PLANNING COMMISSION MEETING

RE: The Avalon- f.k.a. White Lake Hill- Preliminary Site Plan Review – 3rd Review

PRELIMINARY SITE PLANS
THE AVALON
 HIGHLAND ROAD
 WHITE LAKE TOWNSHIP, OAKLAND COUNTY, MICHIGAN

DRAWING TITLE
PRELIMINARY GRADING PLAN - 2

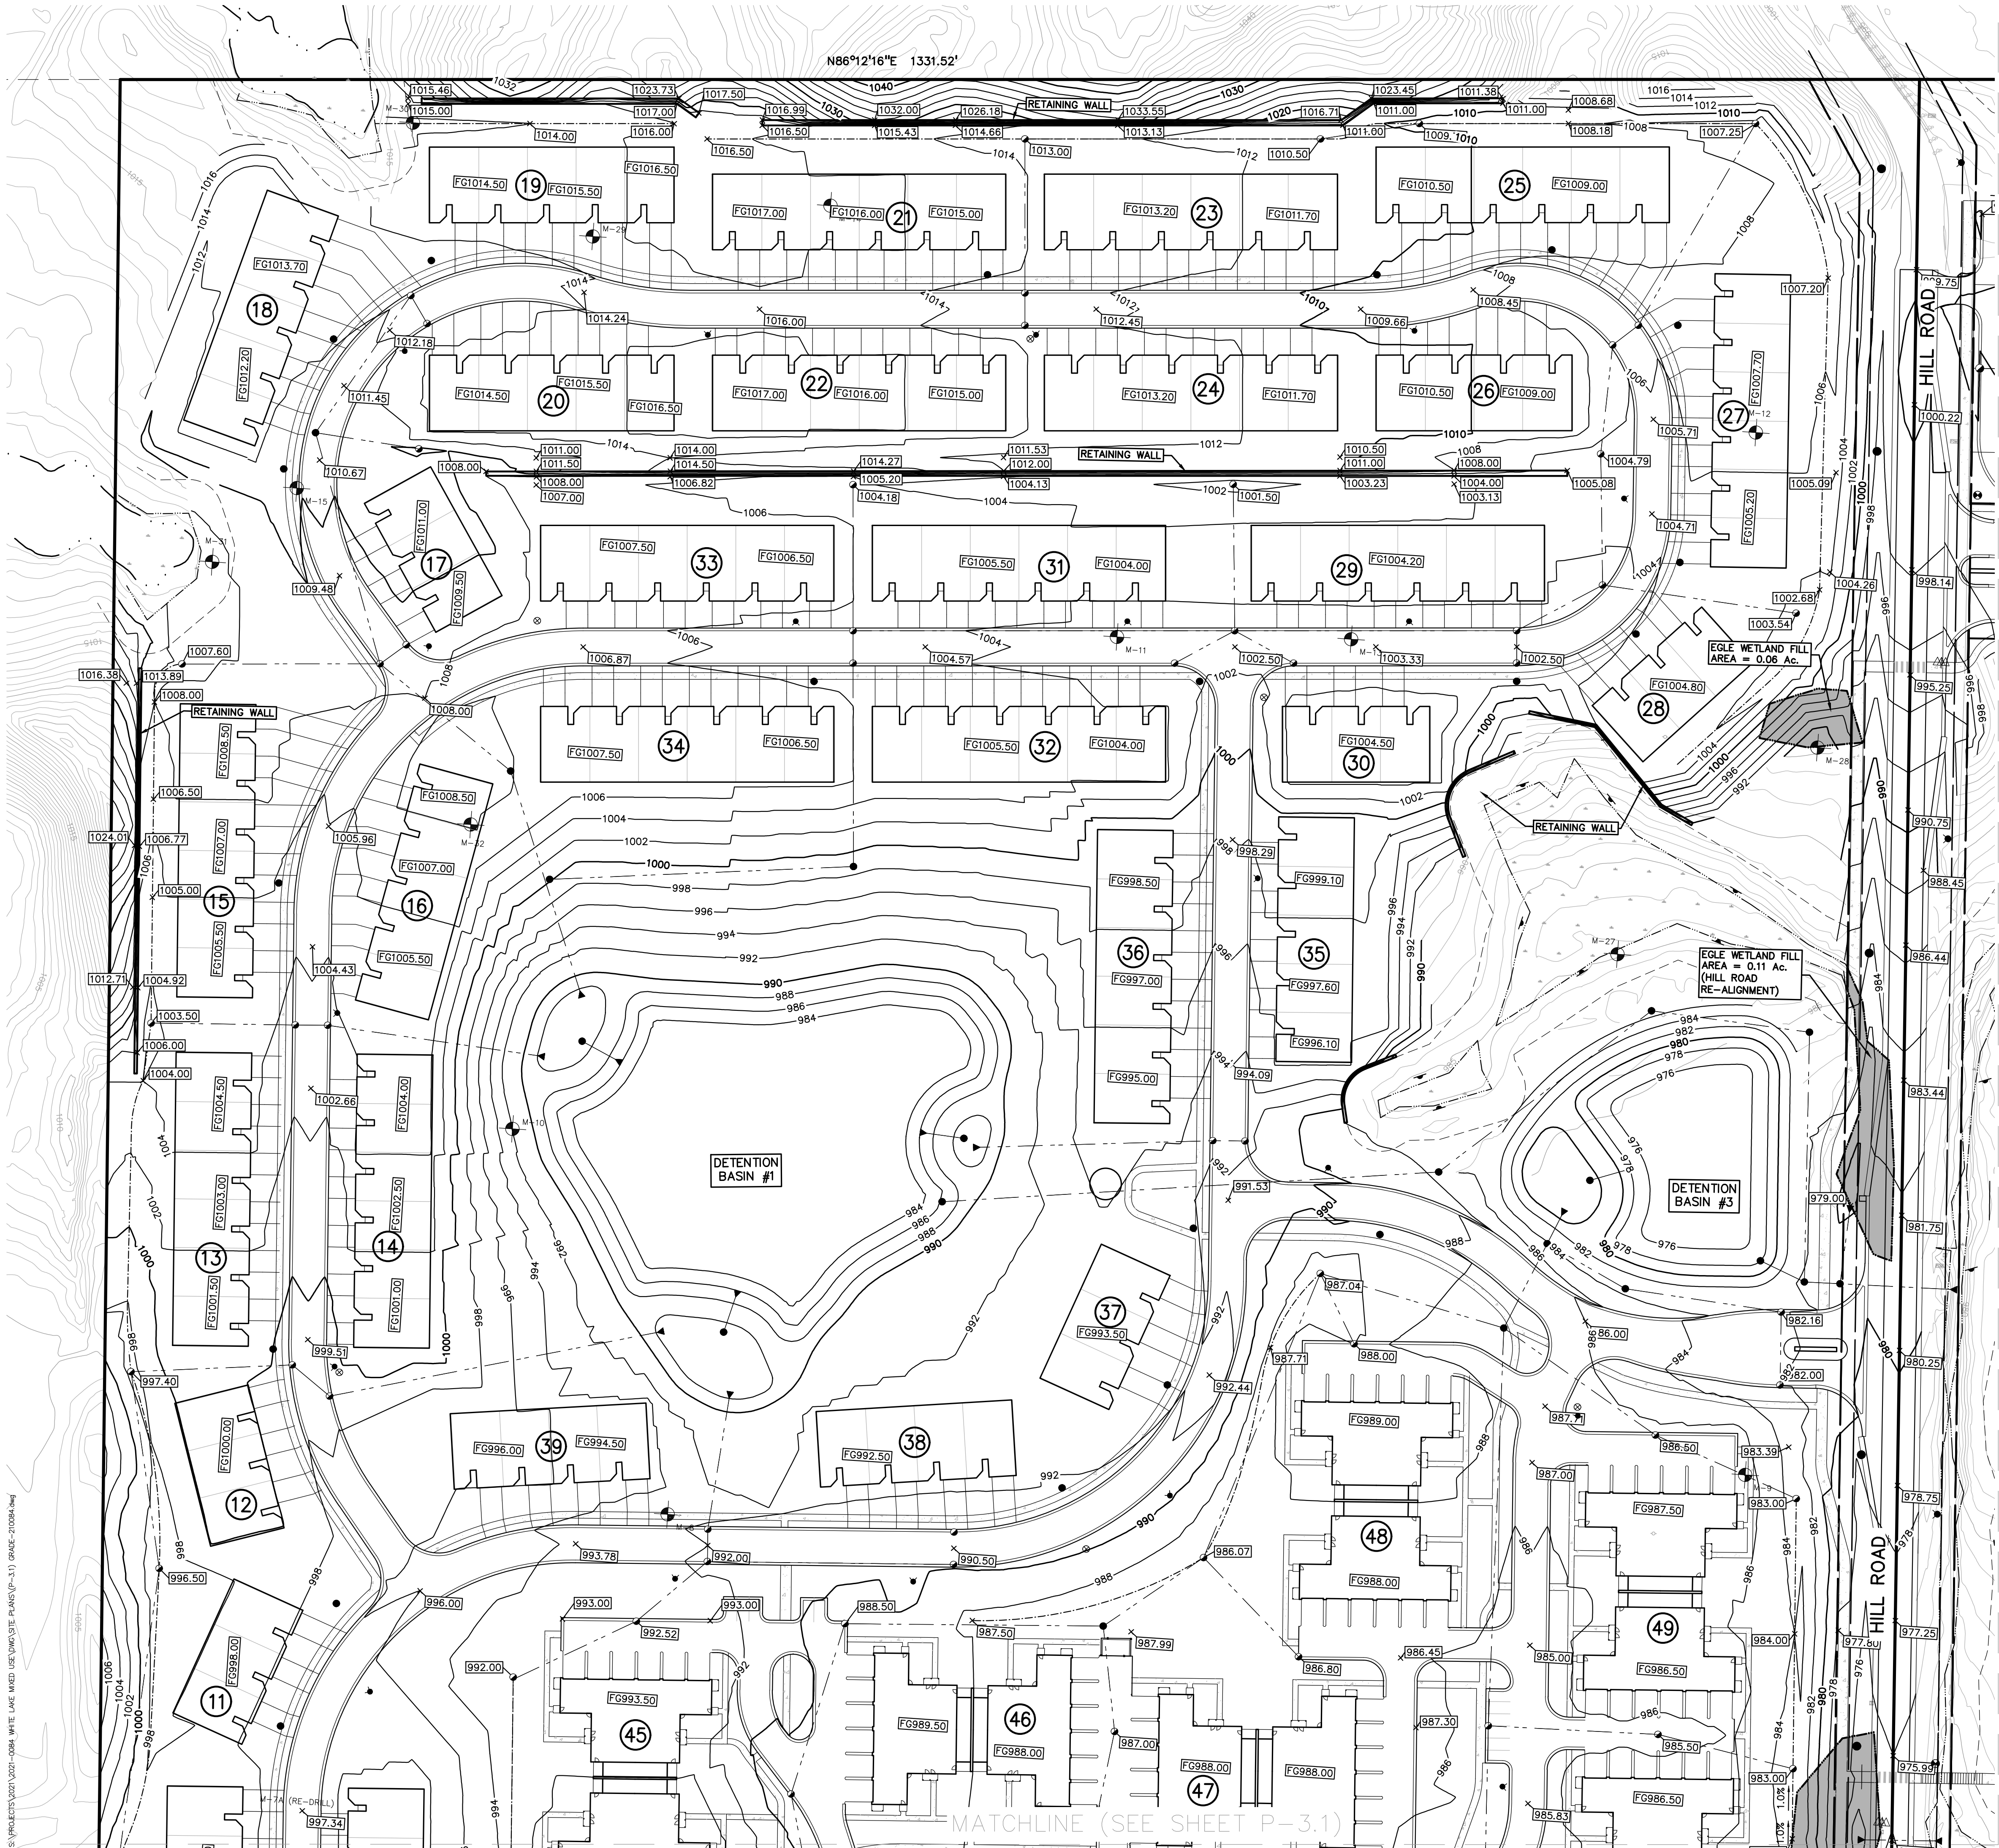
3. Retaining walls >30" in height shall require a decorative fence or railing at the top that is a minimum of 36" in height.
4. Wetland buffers shall be clearly shown on all grading sheets.
5. Sheets 3.1-3.4 have Hill Road mislabeled as Highland Road. Please revise.
